MEETING MINUTES

Location: Vidyo
Date: 1 Sep. 2020
Time: 11am EDT
Indico event: <https://indico.cern.ch/category/8972/>
Attendees: Silvia, Eric, Zenghai, Paolo.
Minute taker: Silvia
Reviewed: N/A

Weekly HL-LHC RFD HOM couplers follow-up meetings.

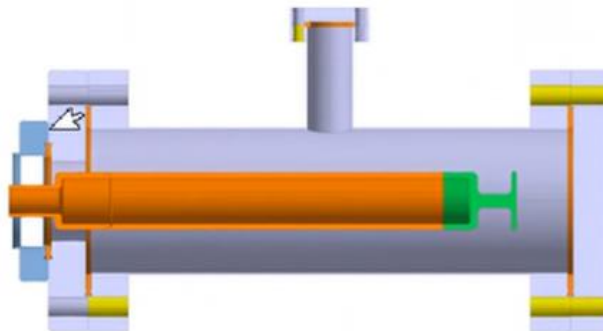
- Eric reports new design cracked during vacuum leak test, even before thermal shock test. Usual practice is to leave small space (0.1 mm) between titanium flange and stainless-steel flange during assembly – see picture below, gap pointed by arrow. Filler gauges or shims can be used during assembly to measure the gap width. If this space does not exist, during cooldown, one flange will push against each other and will put stress on the ceramic. The cavity assembly also has the feedthrough flange (in titanium) mounted onto a stainless-steel flange, and so also in cleanroom assembly we should leave a small space between both flanges. This small gap was not ensured during assembly for the on-going ceramic tests and might be the reason why previous ceramics cracked during thermal shock tests.

- Eric will confirm next week if this is the reason why there are cracks in the ceramic.
 - ACTION ITEMS [Eric, AUP]: The assembly procedures should reflect the necessity to verify that there is 0.1 mm gap between flanges.

more useful in warm qualification of HOM filters.			
41	Confirm brazing materials to Naeem and verify materials list.	Eric	Pending (Sep. 1, 2020)	
42	Assembly procedures should include control step to verify 0.1 mm gap between port flange and feedthrough flange	Eric	Pending (Sep. 1, 2020)	See meeting Sep. 1, 2020.
	Add EDMS No. of HOM drawings to EDMS 2363558 (summary of models and studies reference)	Silvia	Closed	Drawings listed in the ICD.
	Generate summary drawing with RF ancillaries dimensions	Eric	Pending (Apr. 07, 2020)	Not needed anymore.
	Provide markup with corrected numbers	Naeem	Closed	On June 2, 2020, Naeem showed different dimensions for HHOM wall thickness between CERN and AUP drawings.
	Confirm material used for flanges of each RFD RF ancillary	Eric	Closed	Now in the drawings. Check in the drawings.
	Review dimension difference for HHOM wall thickness between CERN and AUP drawings	Eric	Closed
